Approved Replacement Turbocharger

5303-970-0623 / 5303-970-0634 / 5303-970-0394

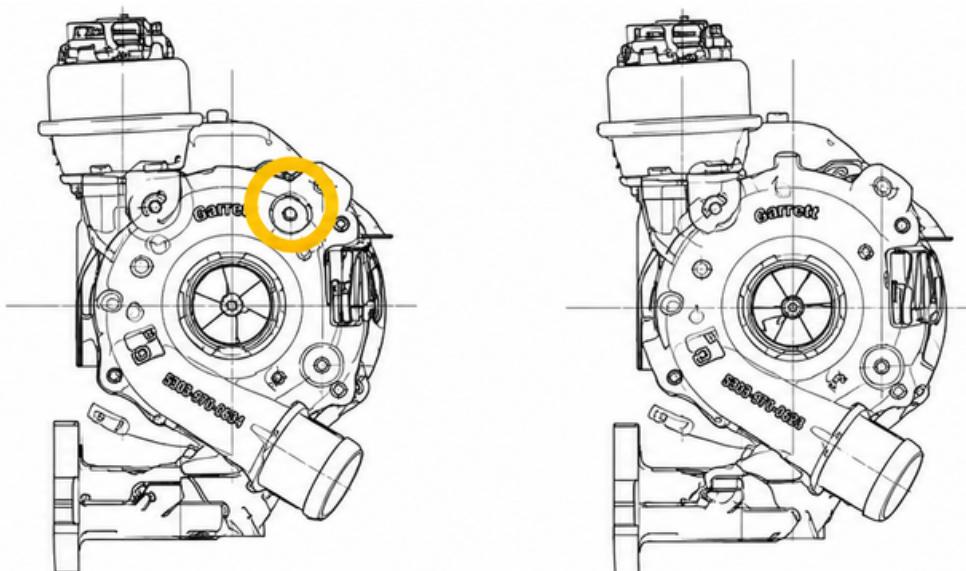
The previous turbochargers had different applications:

- 5303-970-0634 – Suitable for PSA/Vauxhall vehicles only. Not suitable for Ford applications due to a missing compressor housing boss.
- 5303-970-0394 – Used for Ford applications but experienced production issues.

In addition, both turbochargers use different VTG (variable turbine geometry) designs and therefore different turbine housings.

The new 5303-970-0623 combines the correct features of both previous versions:

- Turbine housing and actuator from 5303-970-0634
- Compressor housing with two mounting bosses, as used on 5303-970-0394

5303-970-0623 supersedes both previous part numbers.
